Forsyth County Procurement

ADDENDUM #6

RFP 20-78-1620

For: Providing all labor, equipment and materials for the construction of a new Juvenile Justice Center at 875 Lanier 400 Parkway, Cumming, GA 30040. Project includes a multi-phased site development, demolition of existing motel structures and construction of new 62,000 square foot Juvenile Court building.

Sheet No. **A-5.73**
RELEASED FOR CONSTRUCTION

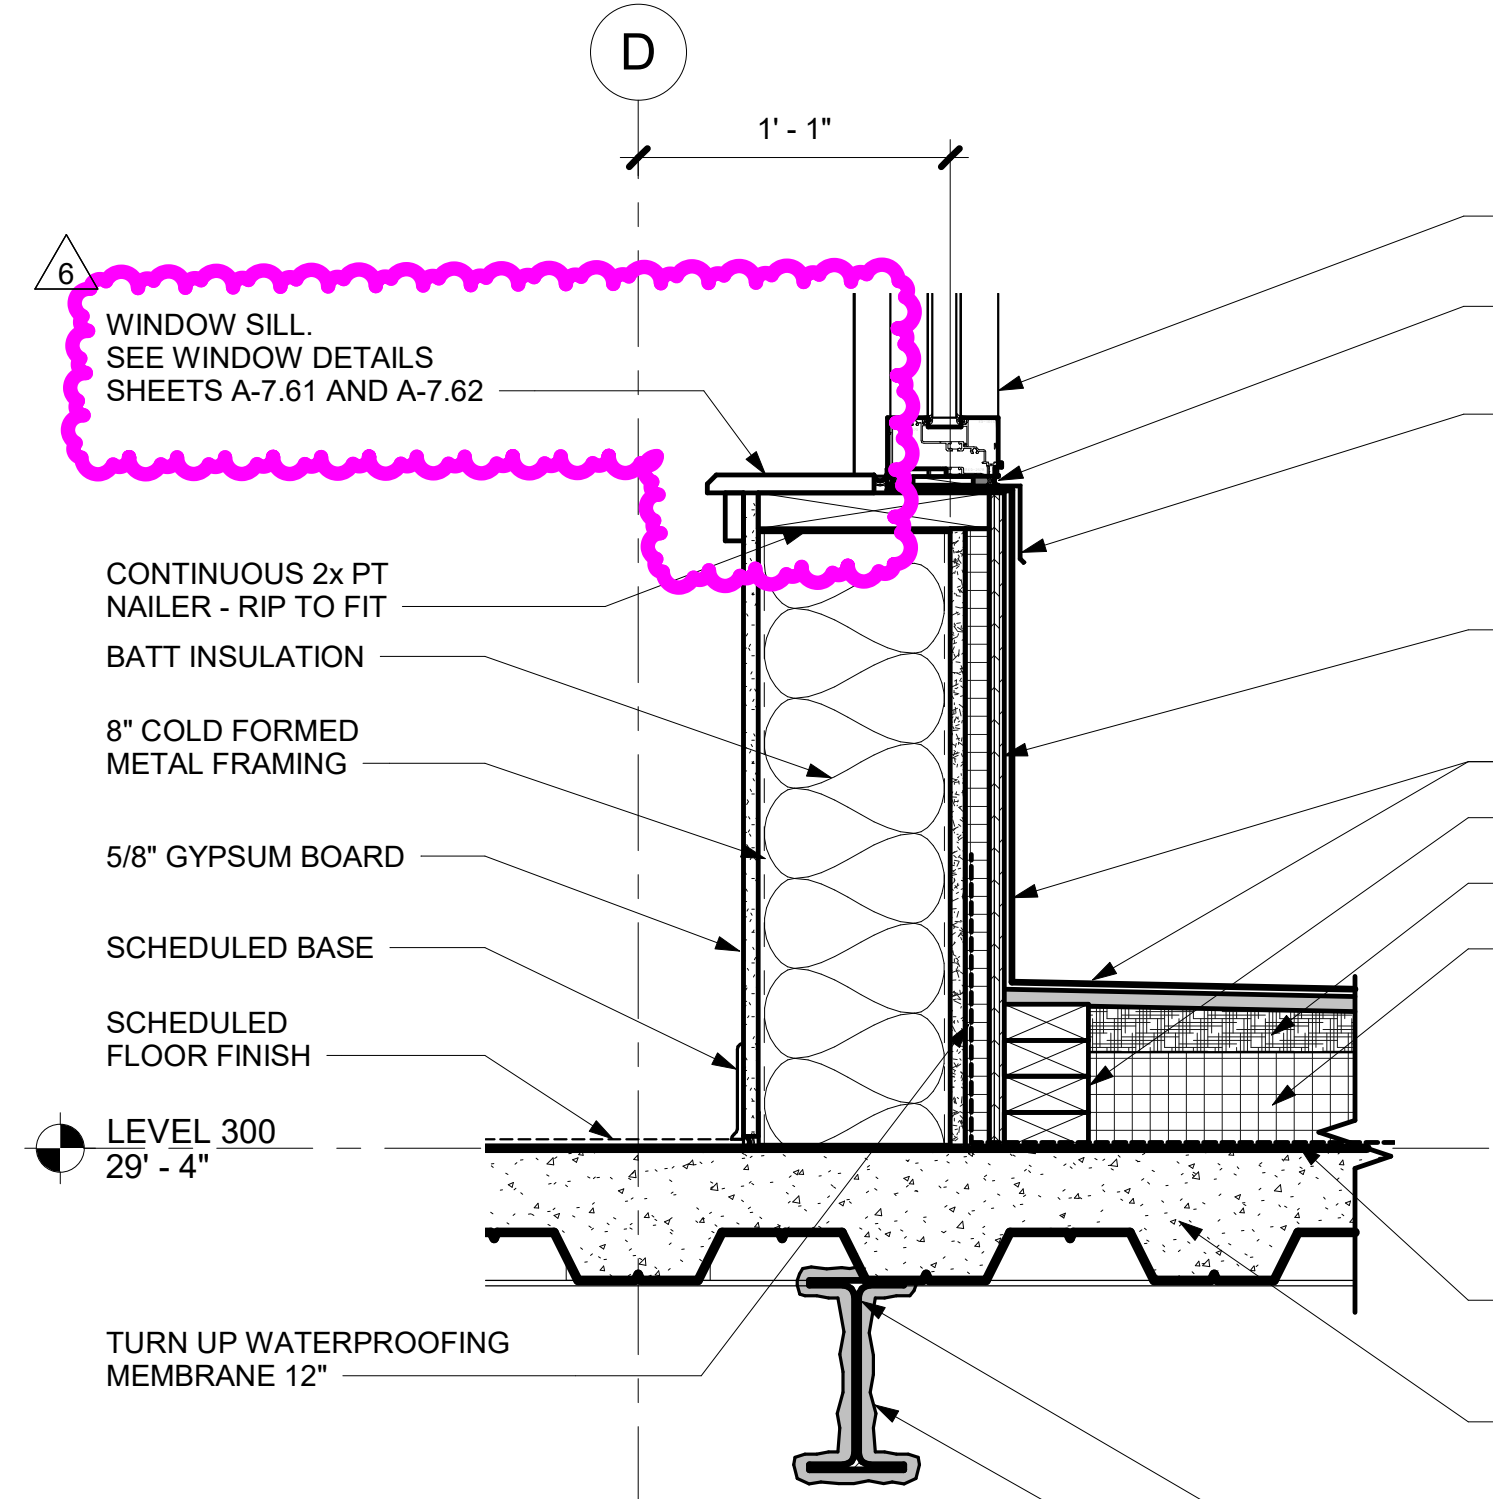
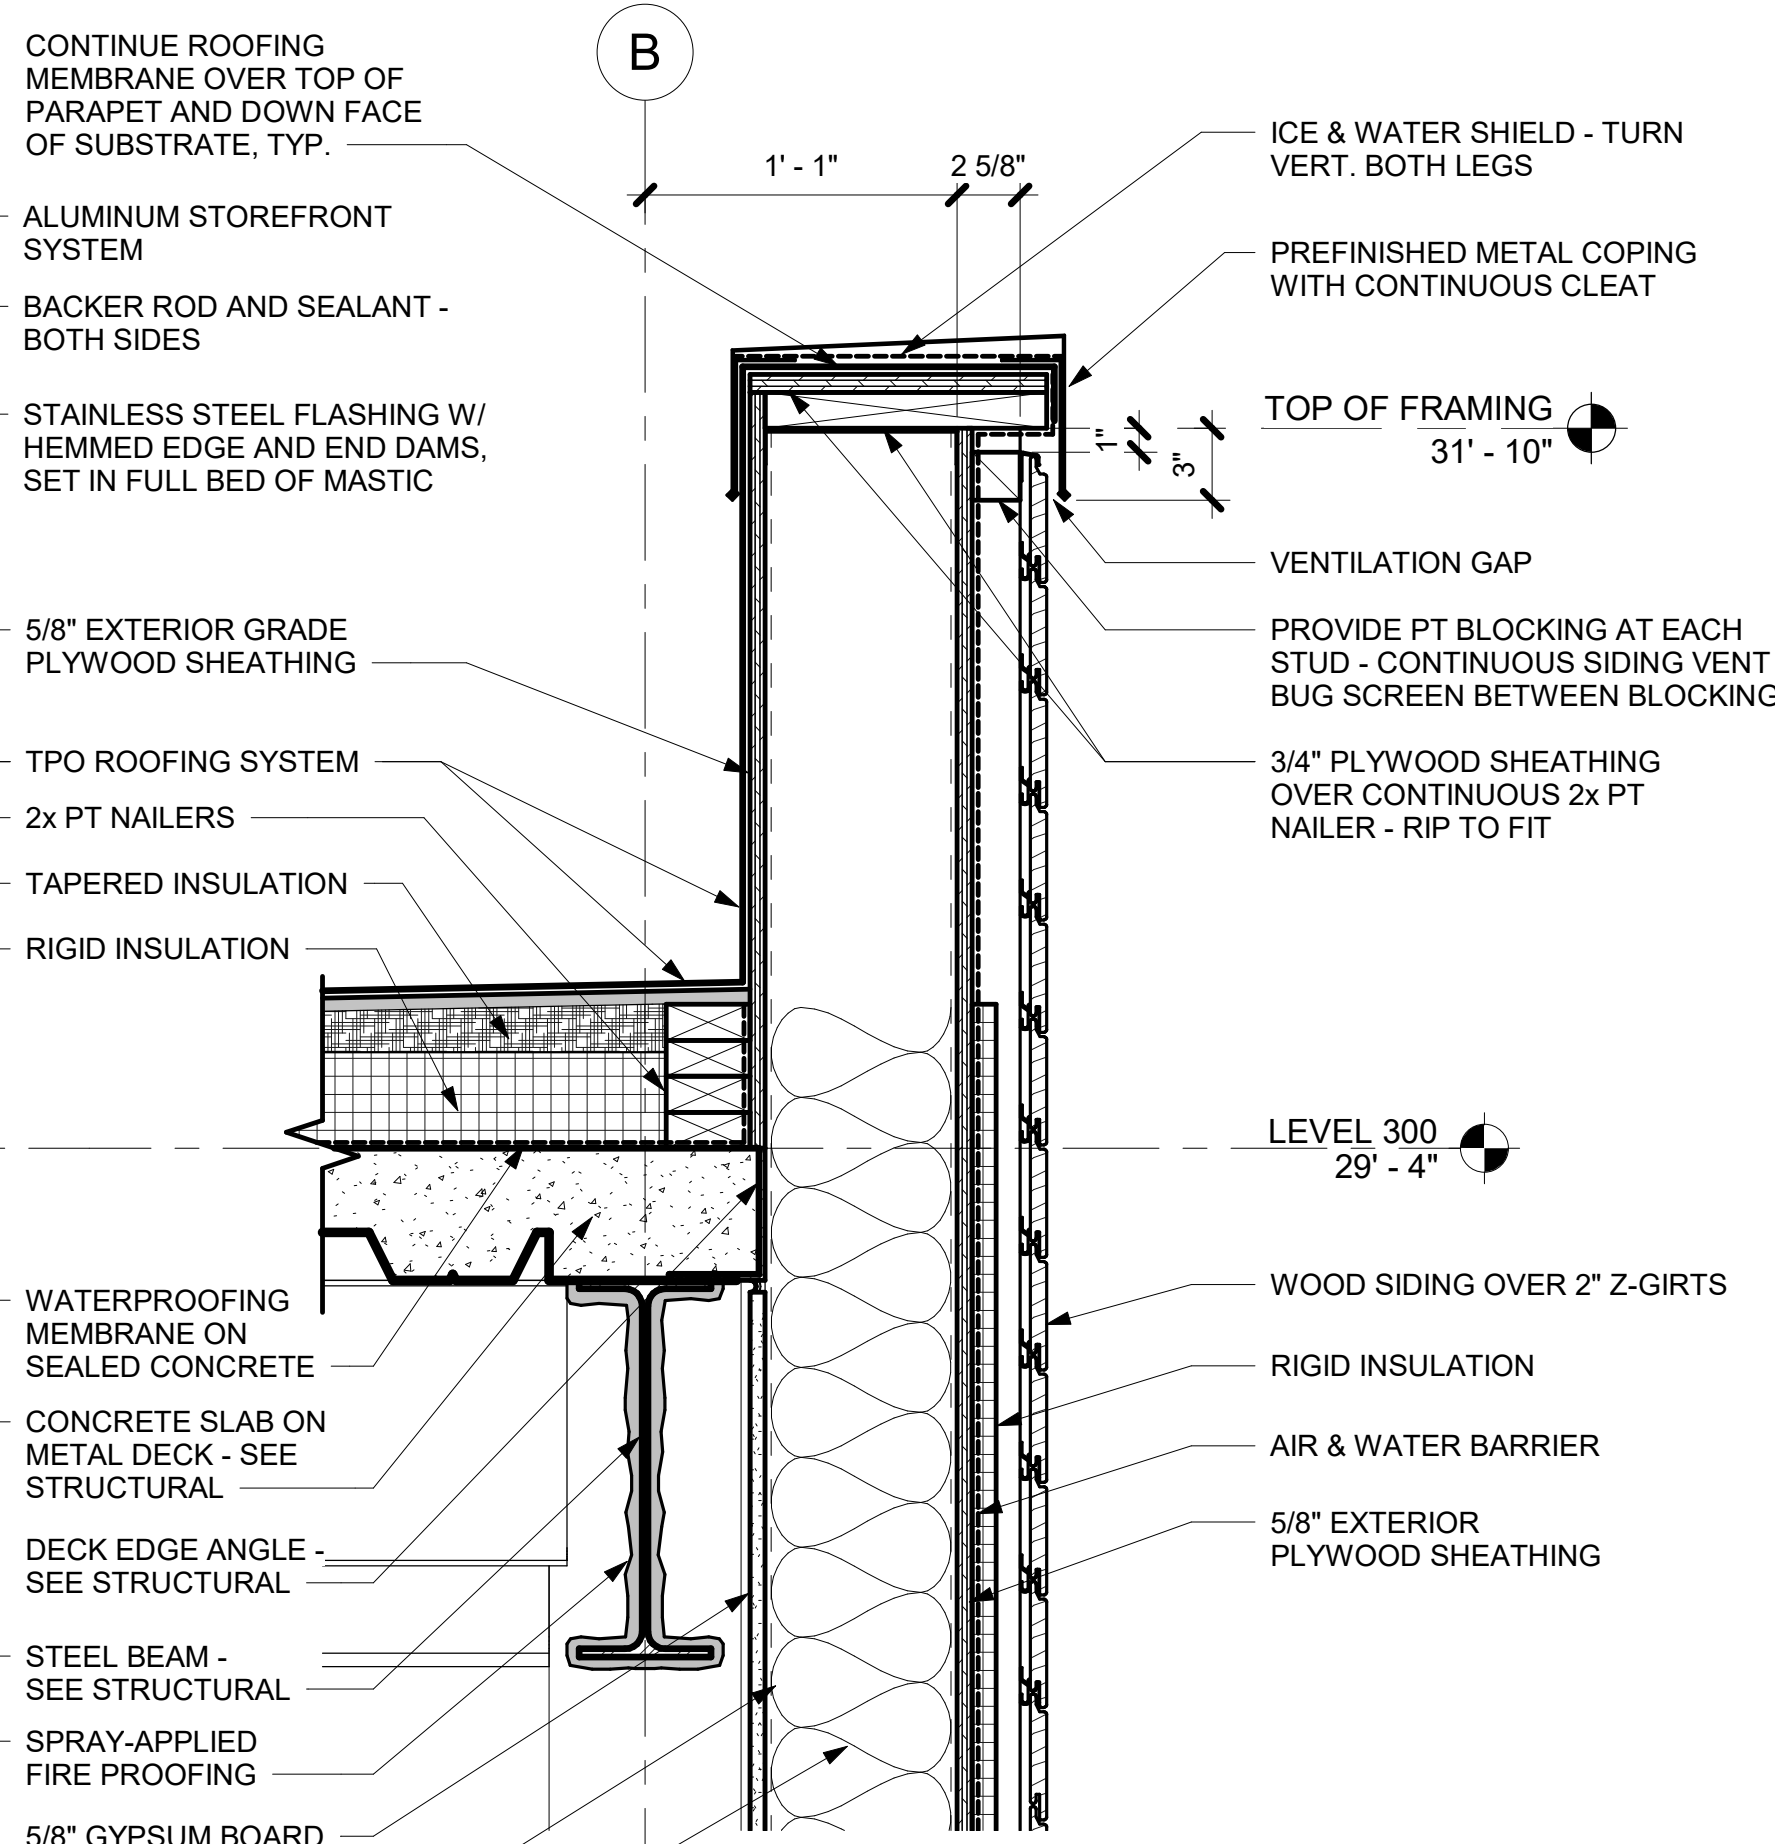
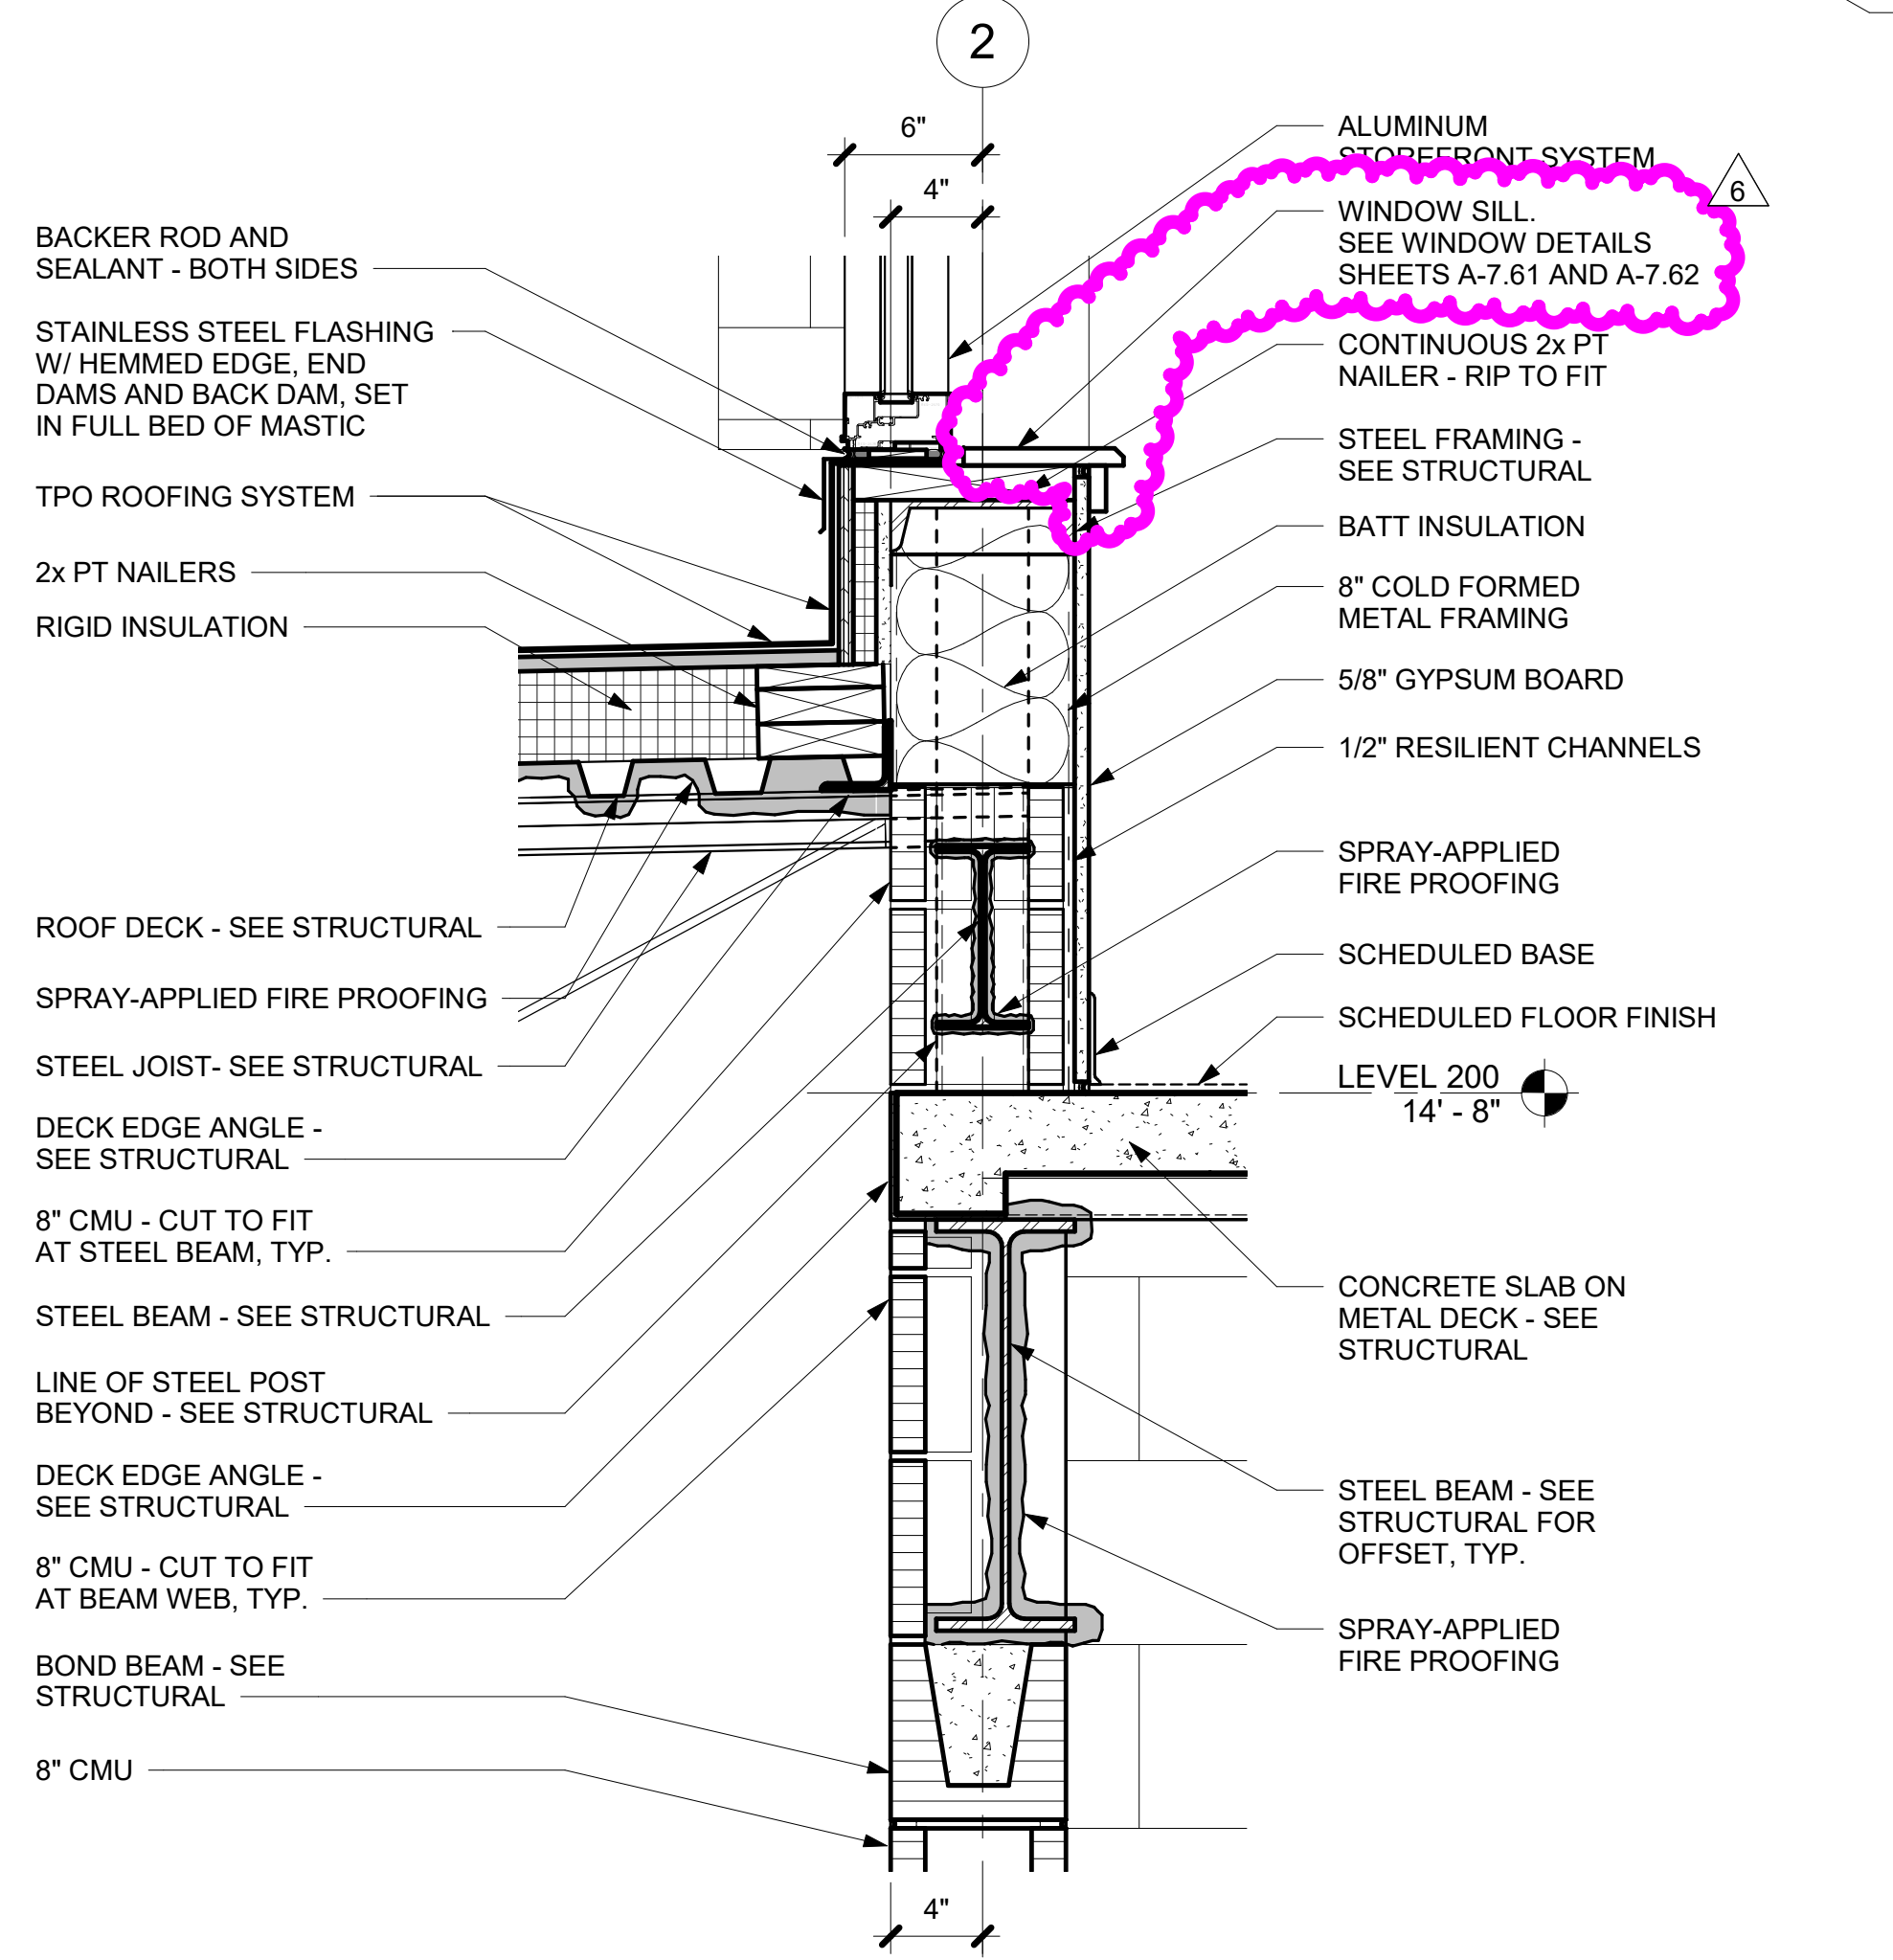
71. Detail 9/A-5.73, window sill note says, “see interiors”. There is no window sill information on interior drawings, please clarify what material window sills are made of.

1. Removed references to “SEE INTERIORS” on window sill details.
 2. Reference sheet A-5.73 SECTION DETAILS revised under addendum #06 dated 07/16/2020.
